January 25, 2011

Re: Savannah Harbor Expansion Project: Draft General Re-Evaluation Report and Draft Tier II Environmental Impact Statement

**FIGURE 6-1:**  
**Savannah Draft vs Project**

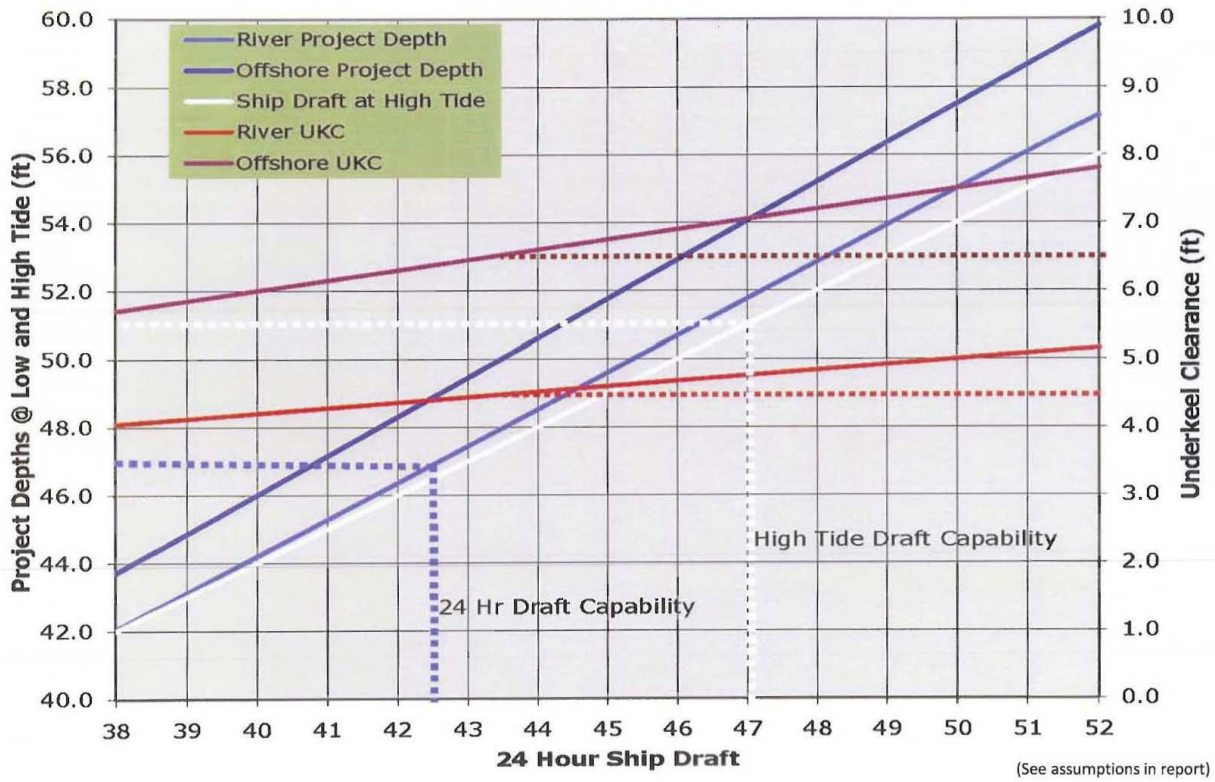
Figure 6-1 estimates draft and under keel clearance capability of various project depths at high and low tide for the Savannah River.

3. Transit time from the sea buoy to Garden City would be three hours, on average.
4. The Army Corps of Engineers channel design standards per their engineering manual on channel design, which requires project depths to be 110 percent of the target ship draft in internal waters and 120 percent in exposed waters, is not being adhered to, as is apparent in the draft GRR and DEIS. Therefore, a lesser standard has been assumed to be 108 percent in internal waters and 115 percent in exposed waters for the purpose of these calculations. It should be noted that International Maritime Organization safe navigation standards for navigation mimic the USACE's standards of 110 percent and 120 percent respectively.

5. The result of the above assumptions is that an inbound ship will only be afforded 2/3 maximum tidal assistance at some point on their inbound voyage due to the duration of the voyage and the tide lag from the sea buoy to the terminal, and 1/3 of maximum tidal assistance on outbound voyages. The location of the ship at high tide, the speed of the ship, the length of a particular voyage within the project channel, and the actual tide range on a given day, determine actual tide assistance. The gross average of all these factors based on the above assumptions is 3 1/3 feet average benefit of high tide. For the purposes of this analysis, this has been rounded up to four feet, and therefore, this should be considered a liberal analysis, vice a conservative analysis. The USACE should report their findings and determinations on all of these factors and based economic projections on actual ship drafts this project can accommodate within Army Corps channel design standards.

**FIGURE 6-1:**  
**Savannah Draft vs Project**

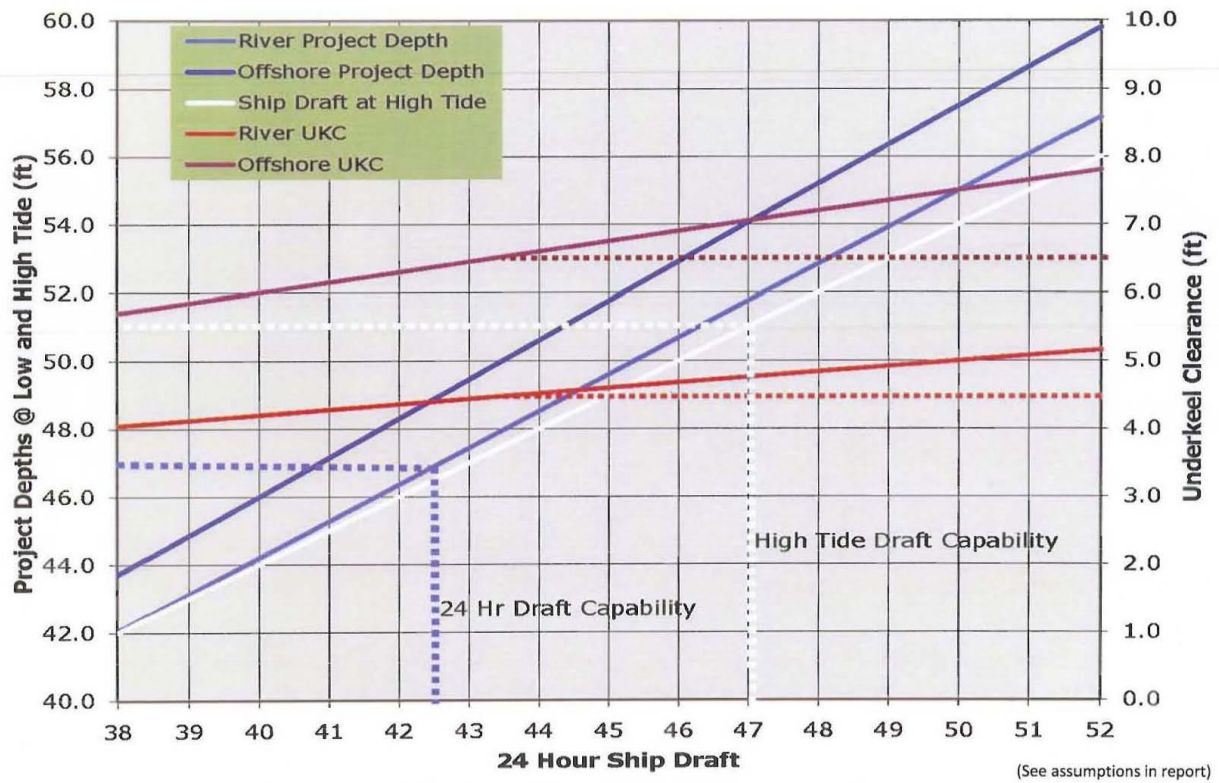
Figure 6-1 estimates draft and under keel clearance capability of various project depths at high and low tide for the Savannah River.

3. Transit time from the sea buoy to Garden City would be three hours, on average.
4. The Army Corps of Engineers channel design standards per their engineering manual on channel design, which requires project depths to be 110 percent of the target ship draft in internal waters and 120 percent in exposed waters, is not being adhered to, as is apparent in the draft GRR and DEIS. Therefore, a lesser standard has been assumed to be 108 percent in internal waters and 115 percent in exposed waters for the purpose of these calculations. It should be noted that International Maritime Organization safe navigation standards for navigation mimic the USACE's standards of 110 percent and 120 percent respectively.

5. The result of the above assumptions is that an inbound ship will only be afforded 2/3 maximum tidal assistance at some point on their inbound voyage due to the duration of the voyage and the tide lag from the sea buoy to the terminal, and 1/3 of maximum tidal assistance on outbound voyages. The location of the ship at high tide, the speed of the ship, the length of a particular voyage within the project channel, and the actual tide range on a given day, determine actual tide assistance. The gross average of all these factors based on the above assumptions is 3 1/3 feet average benefit of high tide. For the purposes of this analysis, this has been rounded up to four feet, and therefore, this should be considered a liberal analysis, vice a conservative analysis. The USACE should report their findings and determinations on all of these factors and based economic projections on actual ship drafts this project can accommodate within Army Corps channel design standards.

**FIGURE 6-1:**  
**Savannah Draft vs Project**

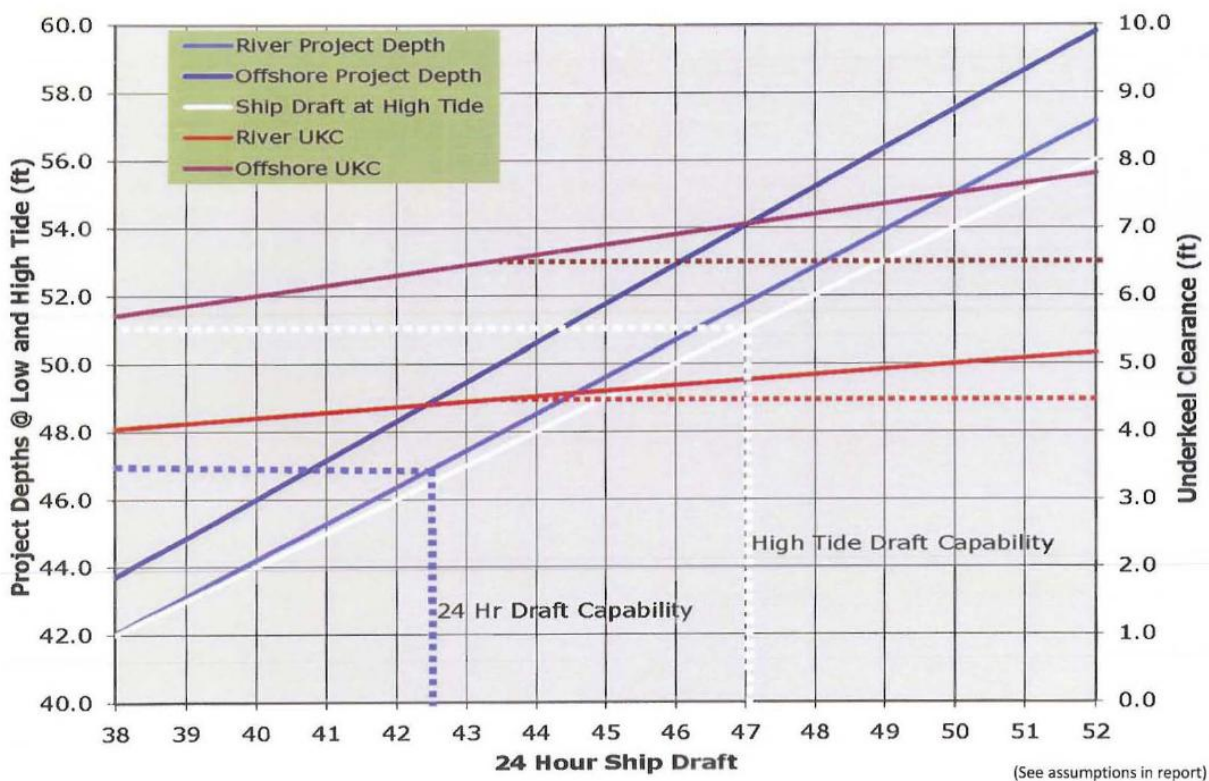
Comment:

**Response:** The graph does not include tidal lags and ranges; it only shows drafts and underkeel clearances that correspond to depths based on different h/T ratios. As noted, these h/T ratios are only designed to provide conceptual design guidance, not final designs based on detailed analysis using risk-based models and/or field or lab measurements.
